STATE OF WASHINGTON
DEPARTMENT OF ECOLOGY

IN THE MATTER OF COMPLIANCE)
 BY PORTAC, INC. AND)
 PORT OF TACOMA) Docket No. DE 88-S326
)
 Respondents.)
) ORDER ON CONSENT
 PROCEEDINGS UNDER)
 CH. 90.48 RCW)
 _____)

**SEPTEMBER 14, 1988-ADDENDUM 1 TO EXHIBIT B
VOLUME I, REMEDIATION PLAN JUNE 17, 1988
PORTAC LOG SORT YARD
PORT OF TACOMA, WASHINGTON**

TO: Carol Fleskes
FROM: Scott Morrison *SM*
SUBJECT: PORTAC Log Sort Yard Remediation Plan
Comments by Scott Morrison, Mike Kuntz, and Dave Cummings

Figure 1

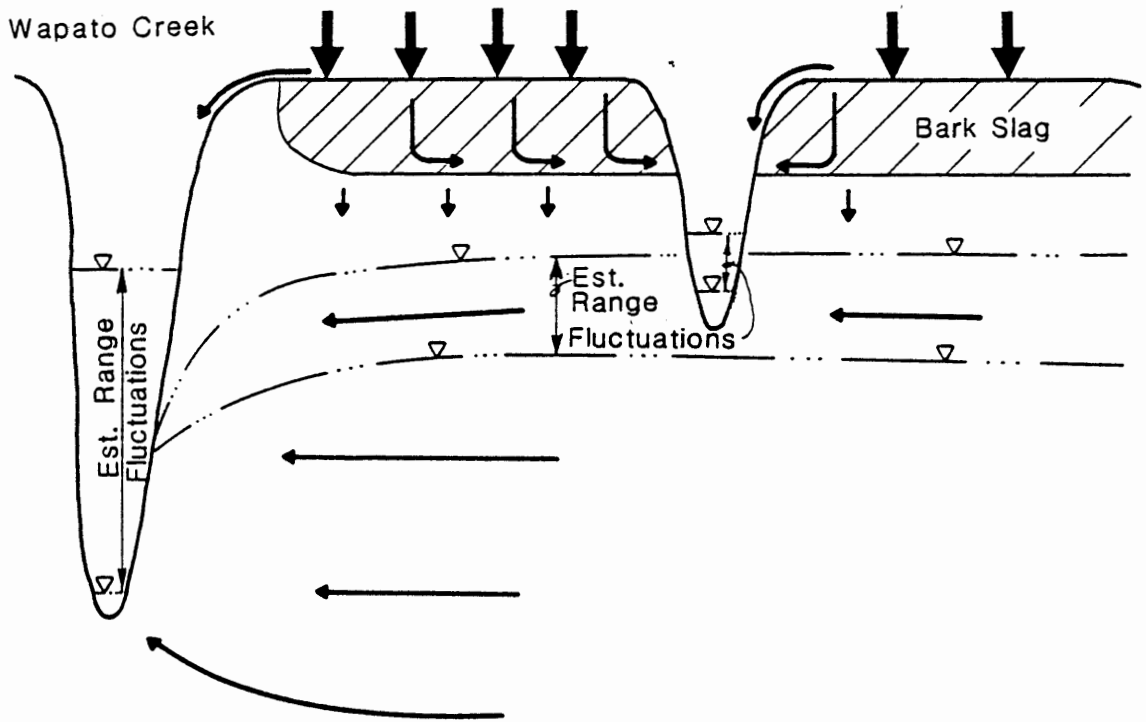
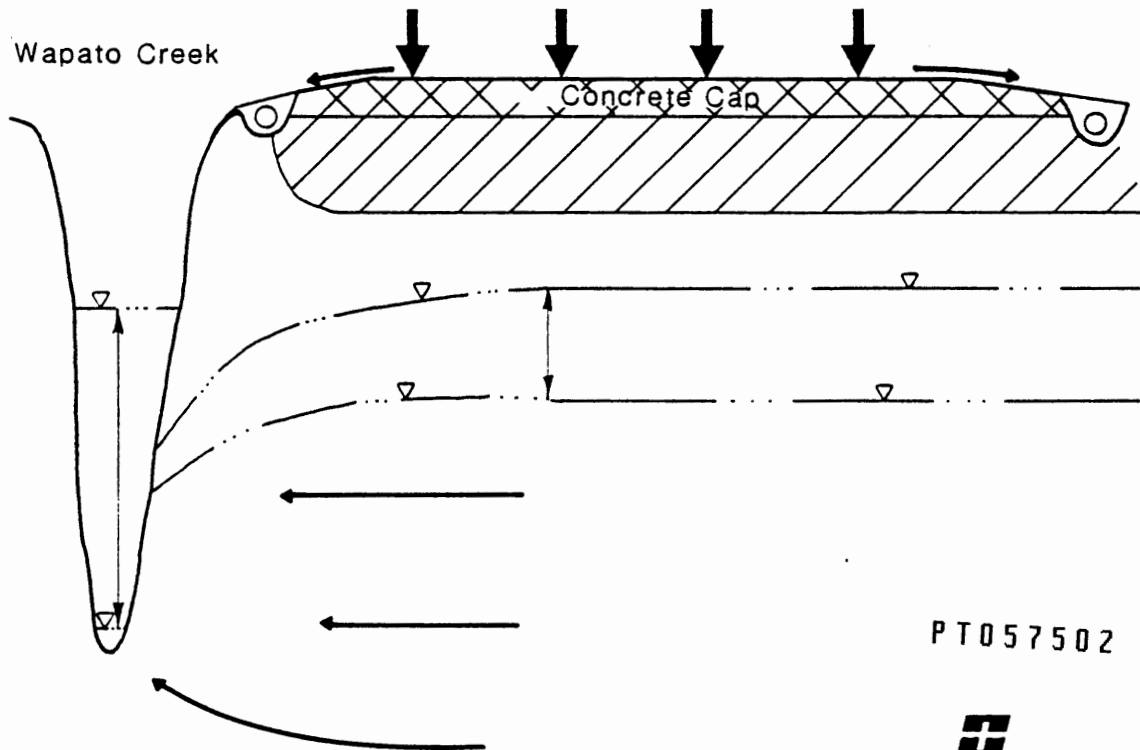
Surface water is defined as overland flow and shallow subsurface storm flow. Groundwater is considered to be saturated soils below the water table. Groundwater flow and surface water flow are the two potential pathways for metals migration from the site to Wapato Creek. Our observations from the site investigations indicate that precipitation falling on the Portac site either runs off the site and discharges to

surface water or slowly infiltrates to the water table. See Figure 1 attached.

Hart Crowser, Inc.
J-1773-04 9/88
Figure 3

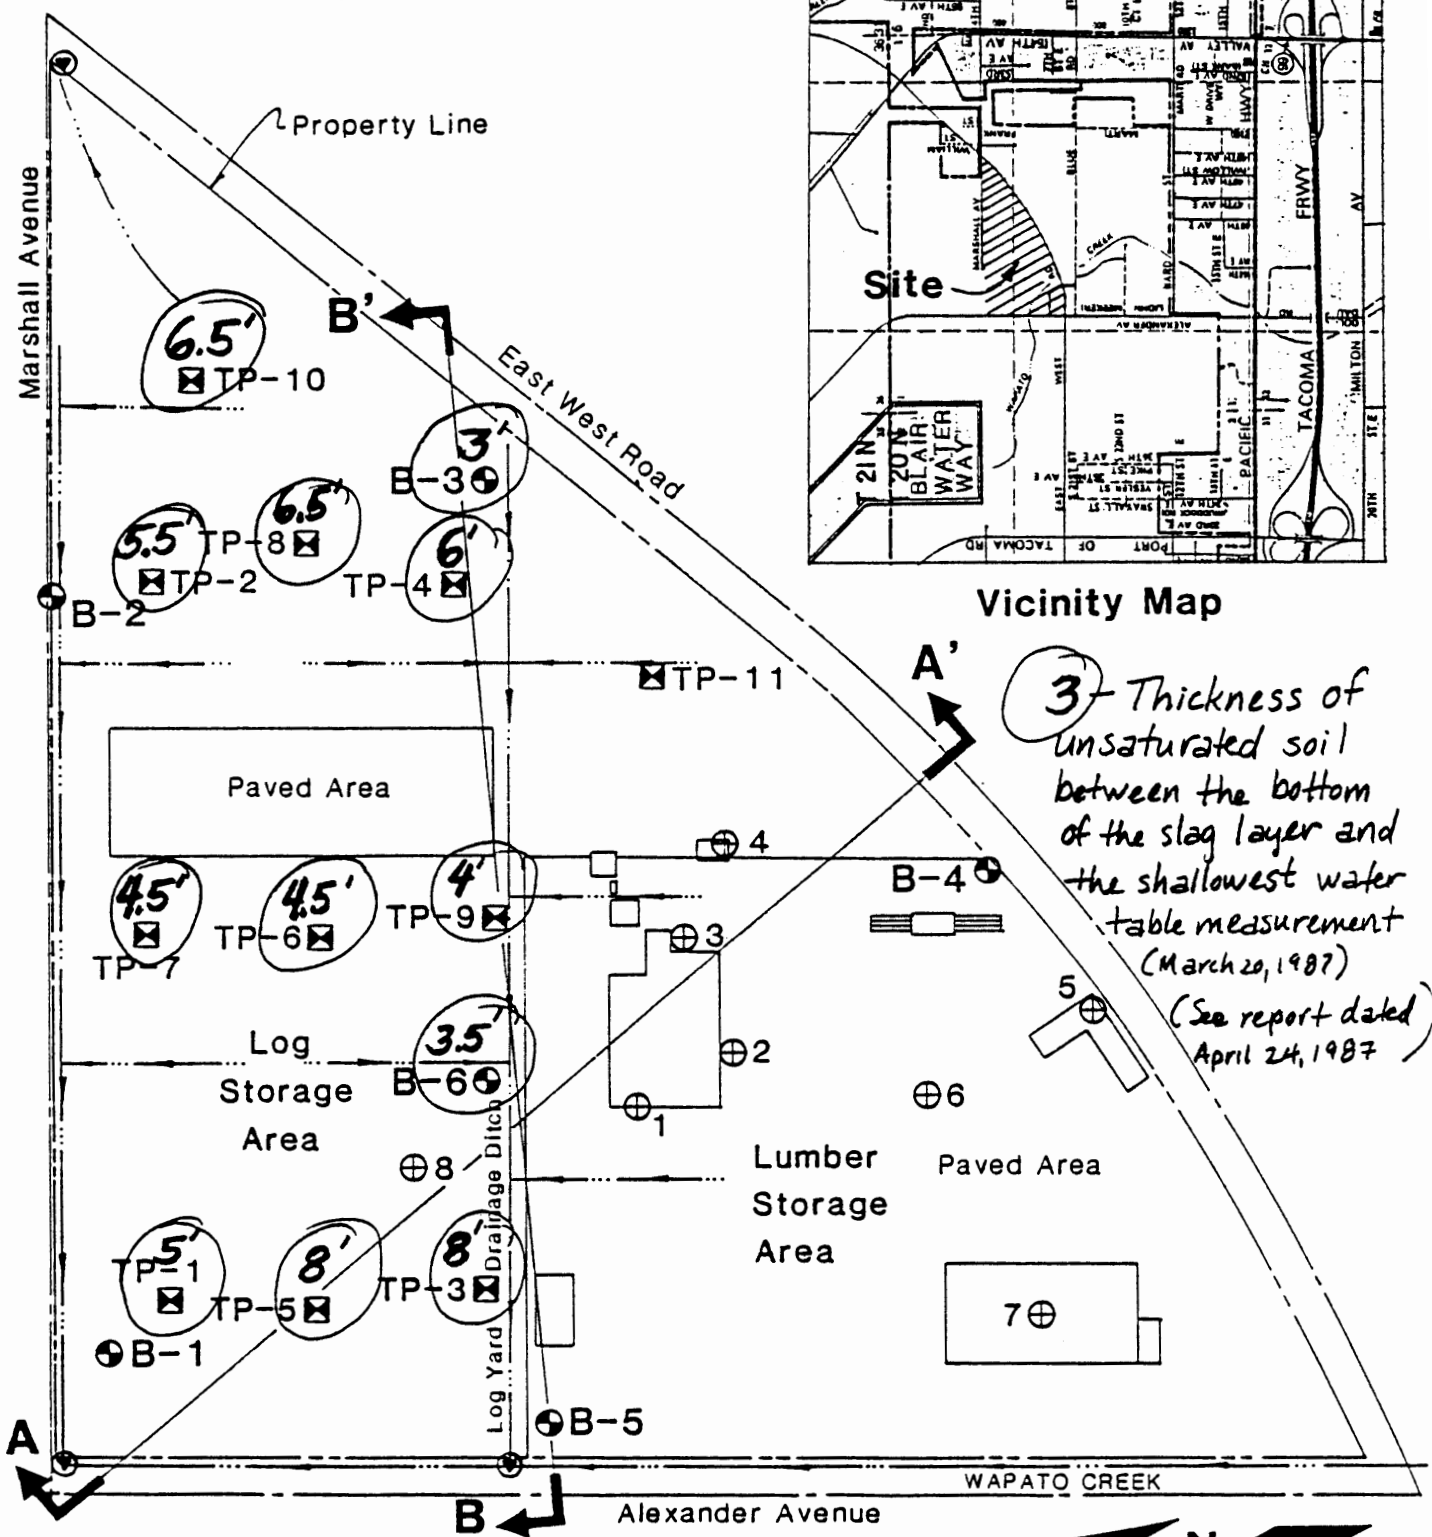
The water level fluctuations were used to assess whether the water levels will rise into the slag. Because the ground surface, slag occurrence, and groundwater levels vary across the site it was necessary to compare elevation data at various points across the site. Our analyses of the base of slag elevation and the water level elevation are presented in detail in Appendix F. Figure 3 (attached) presents a plan of the site showing the thickness of the unsaturated soil between the bottom of the slag and the water table using 4/87 data which is close to the high water level.

Based on our estimated maximum fluctuation of 4 to 5 feet and the reasonable assumption that the April 1987 data are close to the high level, it still appears unlikely that the groundwater level will rise into the slag. Even a 2-foot higher water level than the highest recorded to date

will leave at least 1 foot of unsaturated conditions between the bottom of the slag and the water table (as can be seen from Figure 3).
